**ADDENDUM #1**

**TO:** BIDDER  
**FROM:** ANDRE-ANNE CHENAILLE  
**SUBJECT:** WHITMAN ROAD CULVERT REPLACEMENT PROJECT  
**DATE:** 8 APRIL 2026  
**CC:** TOWN OF HANCOCK

Re: Second Addendum to Geotechnical Engineering Report for New Box Culvert on Whitman Rd in Hancock, MA, File No. 2474

3 Lab Test Results  
C3 Not to Scale

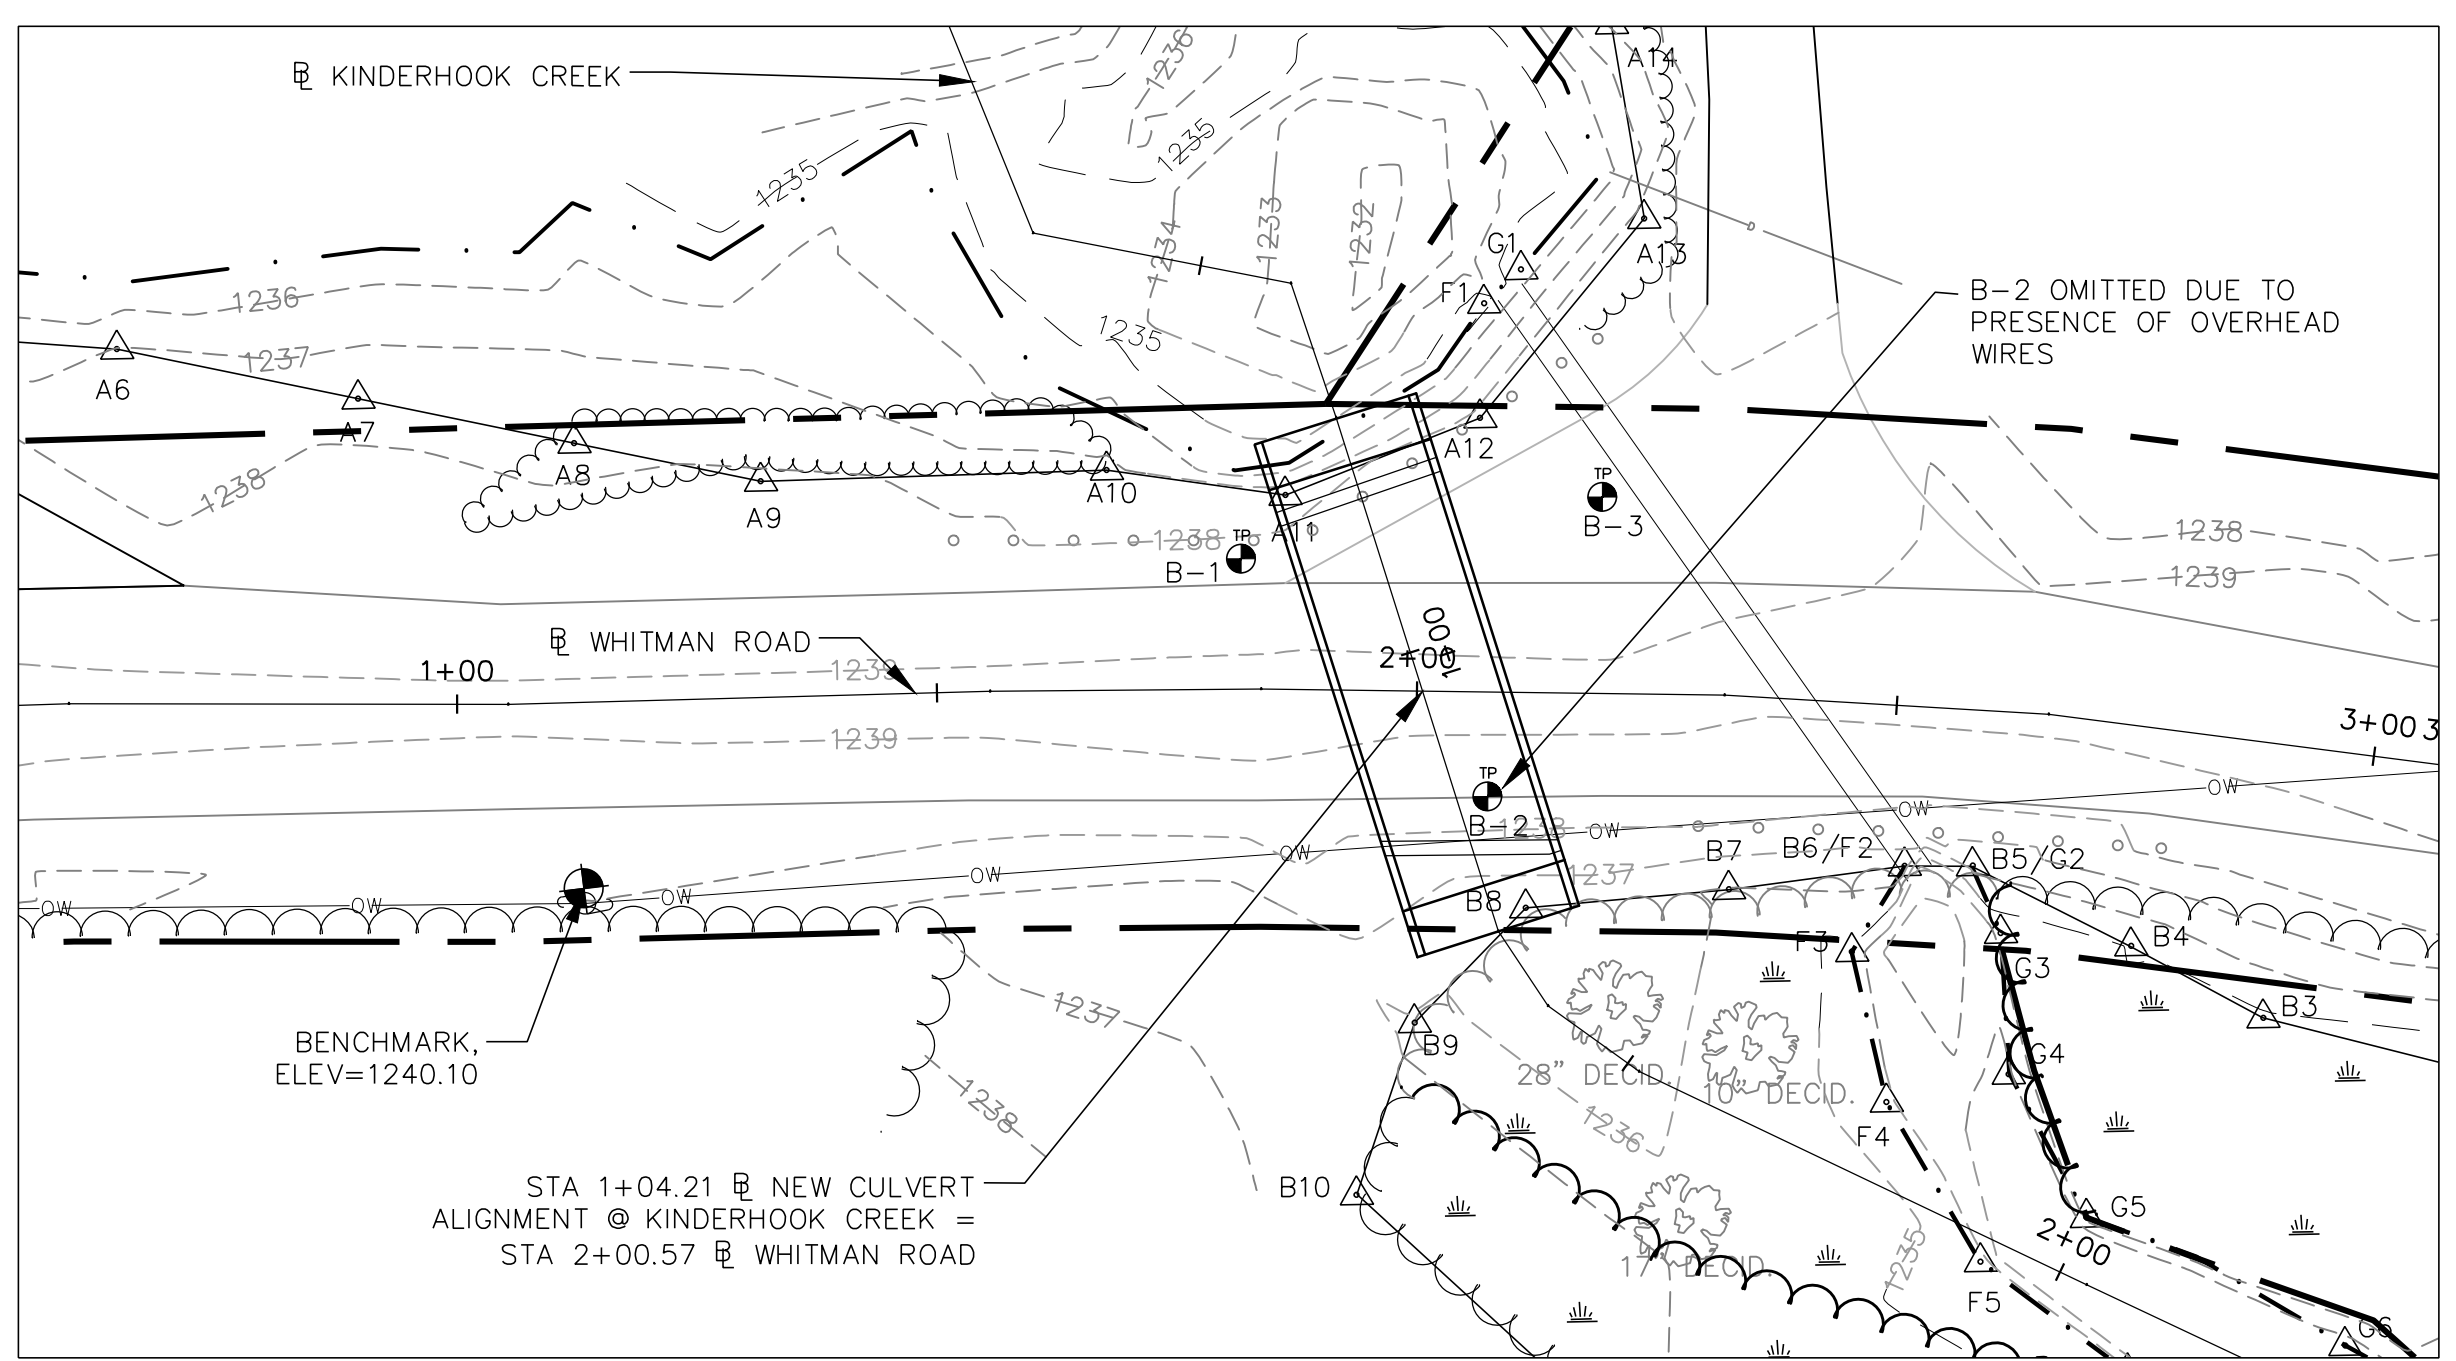
- Due to the potential for unstable soil under the culvert alignment, the Engineer is requiring the Contractor to coordinate with the Owner at least 48 hours in advance to have the Engineer present during excavation of the culvert subgrade for review and approval. The subgrade shall be proof rolled with a minimum 5 ton vibratory roller at least 6 passes. For base bid purposes, the Contractor shall assume an over-excavation of subgrade resulting in 2' of compacted structural fill below the concrete culvert. Any adjustments to this base bid scope as required by the Engineer in the field shall be modified to the contract by change order using supplemental unit prices. See Note 3 under Geotechnical Report Considerations on Sheet 3.

- SOIL BEARING CAPACITY: 2000 PSF. EARTHQUAKE SITE CLASS: D (SEE GEOTECH REPORT FOR DESIGN VALUES)
  - A LAYER OF PEAT WAS OBSERVED BETWEEN 6'-9' WITHIN BORING #3 OUTSIDE OF THE PROPOSED CULVERT ALIGNMENT. THE CONTRACTOR SHALL COORDINATE WITH THE OWNER AT LEAST 48 HOURS IN ADVANCE TO HAVE THE ENGINEER PRESENT DURING EXCAVATION OF THE CULVERT SUBGRADE FOR REVIEW AND APPROVAL. THE SUBGRADE SHALL BE PROOF ROLLED WITH A MINIMUM 5 TON VIBRATORY ROLLER AT LEAST 6 PASSES. FOR BASE BID PURPOSES, THE CONTRACTOR SHALL ASSUME AN OVER-EXCAVATION OF SUBGRADE RESULTING IN 2' OF COMPACTED STRUCTURAL FILL BELOW THE CONCRETE CULVERT. ANY ADJUSTMENTS TO THIS BASE BID SCOPE AS REQUIRED BY THE ENGINEER IN THE FIELD SHALL BE MODIFIED TO THE CONTRACT BY CHANGE ORDER USING SUPPLEMENTAL UNIT PRICES.

**4 Culvert Cross Section**  
 C5 1" = 2'

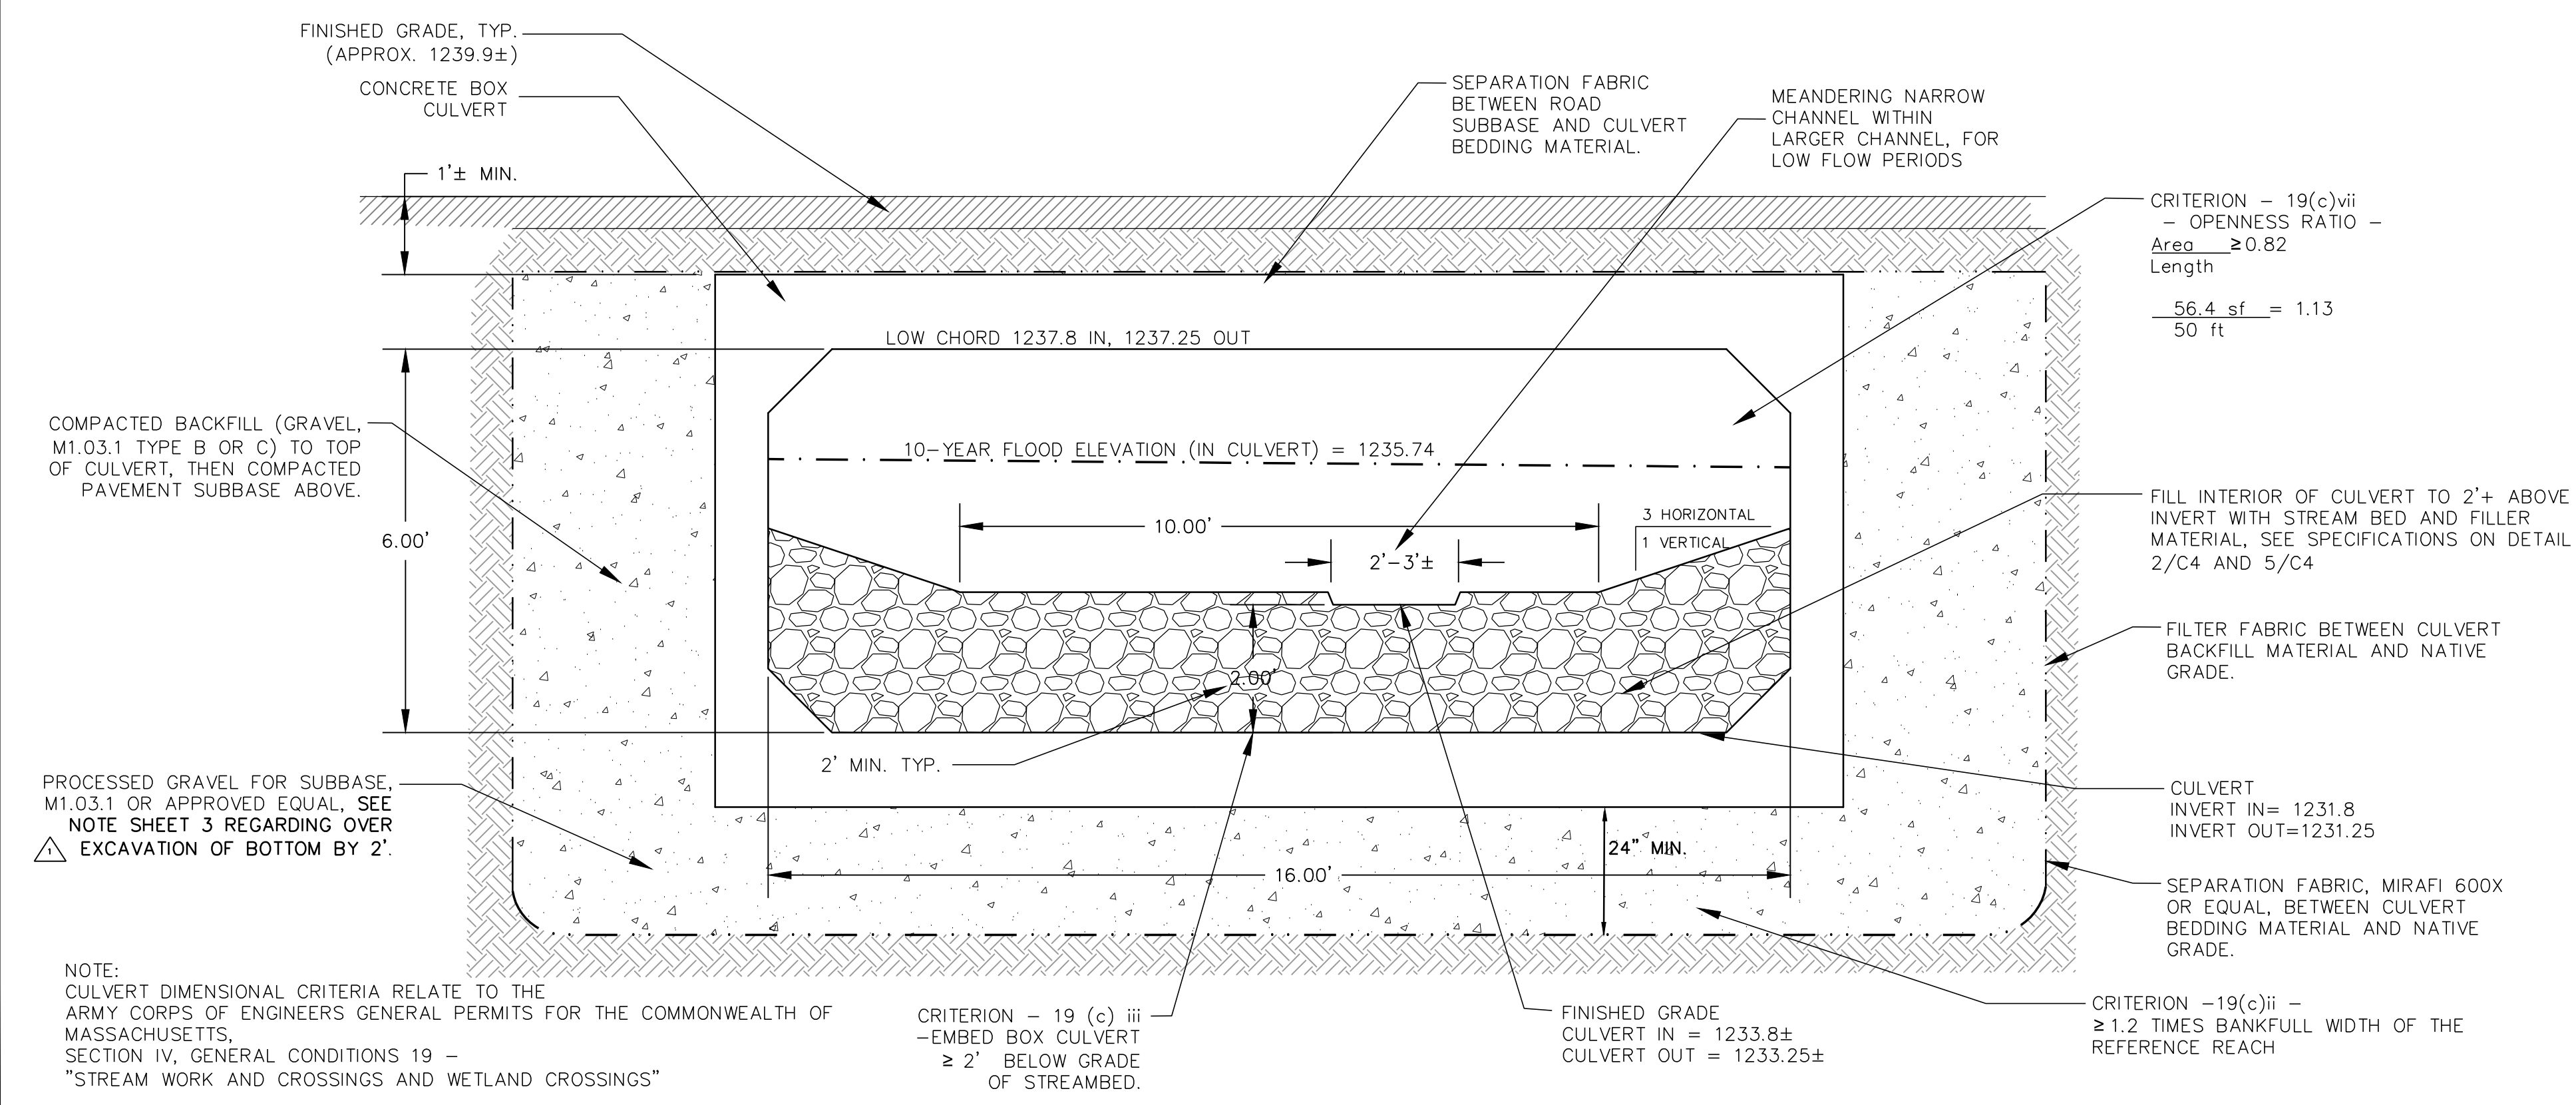
Section 3/C5 of the Guntflow plans show the Culvert Cross Section. The pre excavation vertical pressure or stress on the soil at the culvert bottom is: 9 feet times 120 pcf equals 1080 psf.

The post culvert placement stress on the same culvert bottom is:

1. 2 feet of concrete (top and bottom) times 150 pcf equals 300 psf
2. 10 inch concrete 2 walls thickness 10/12 times 150 pcf times 6 feet tall equals 1500 divided by 17.67 feet equals 85 psf
3. 2 feet of backfill soil in the culvert times 110 pcf equals 220 psf
4. 4 feet of water (fully flooded) times 62.4 pcf equals 250 psf

TOTAL PRESSURE 855 psf

According to AASHTO Design Guidelines, the HL 93 loading is understood to include 2 axles at 32 kips and the front axle 8 kips for a total of 72 kips. A 32 kip axle situated on top of the culvert wall

adds 32 divided by 10 feet (axle length) equals 3.2 klf and divided by 8.83 feet (half the width of the culvert) equals 362 psf. Add this to the 855 psf equals 1217 psf. Finally, the net increase in bearing pressure equals 1217 minus 1080 equals 137 psf.

Assuming that the location of the culvert has experienced similar traffic loading in the past, the soils are preconditioned to support similar loads as those acting down the wall of the culvert, the worst case. Certainly, loose sand with blow counts of 4 to 6 can support a net bearing pressure increase of 137 psf with virtually no settlement. Apply a factor of safety of 3 to this net increase of 137 psf equals 411 psf, which is about 20 percent of the maximum net allowable bearing capacity of 2000 psf recommended in the geotechnical report.

**5 Guardrail Layout Plan**  
 C5 1" = 20'

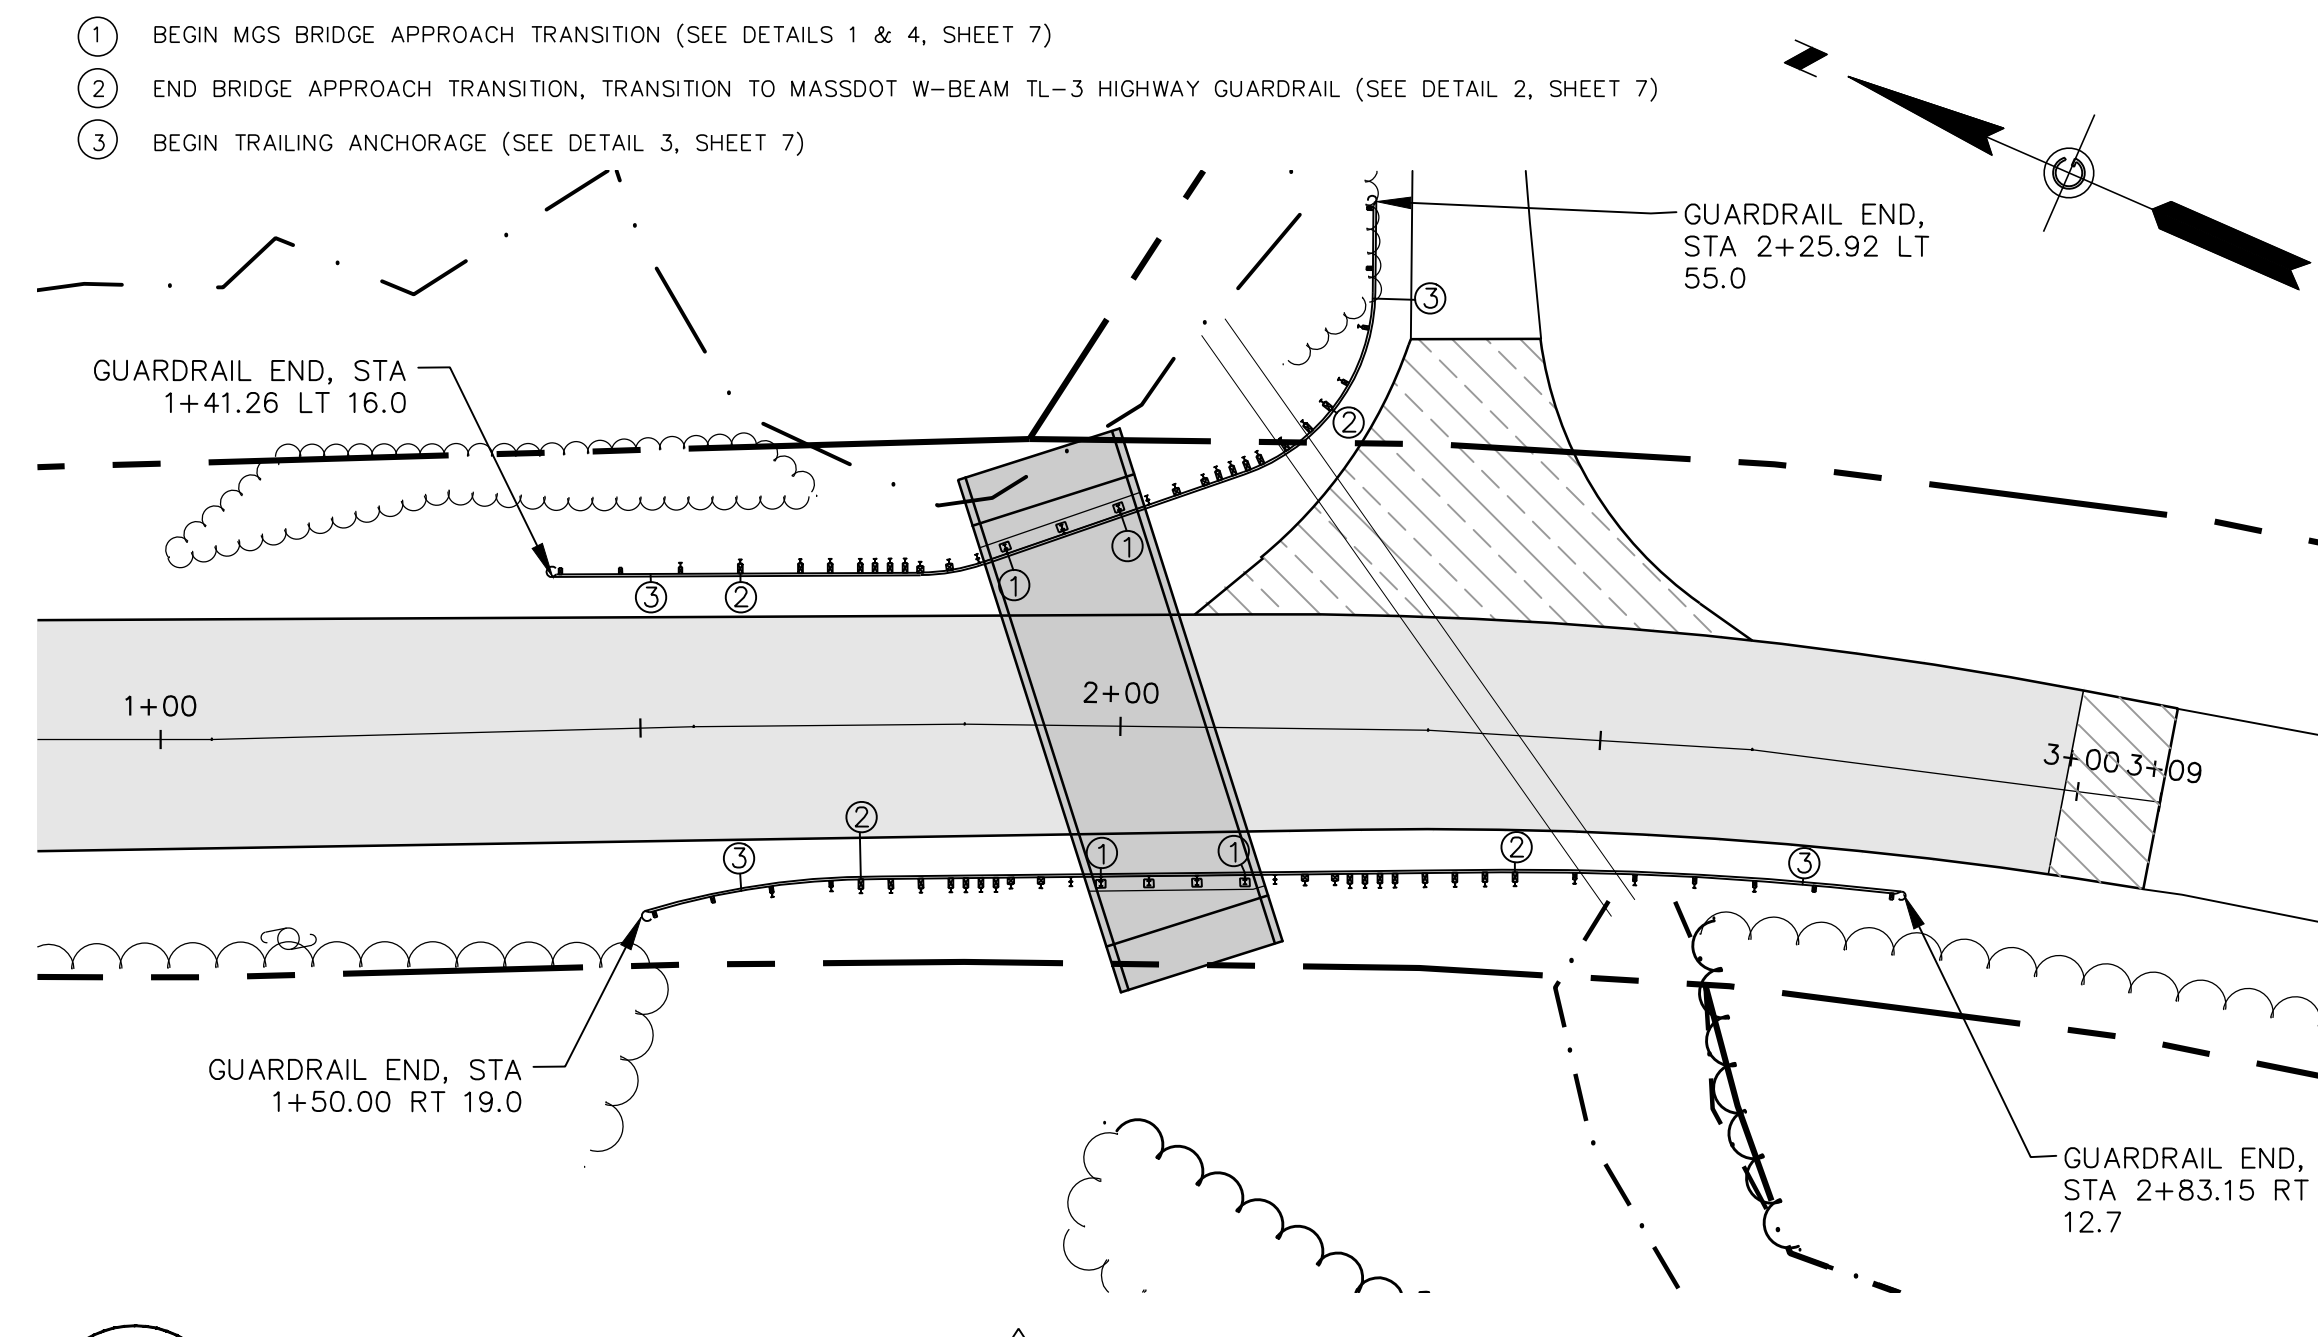
- Additional details have been provided regarding the bridge rail and highway guardrail installation. A Guardrail Layout Plan has been added to Sheet 5, as well as additional guardrail details added to Sheet 7.
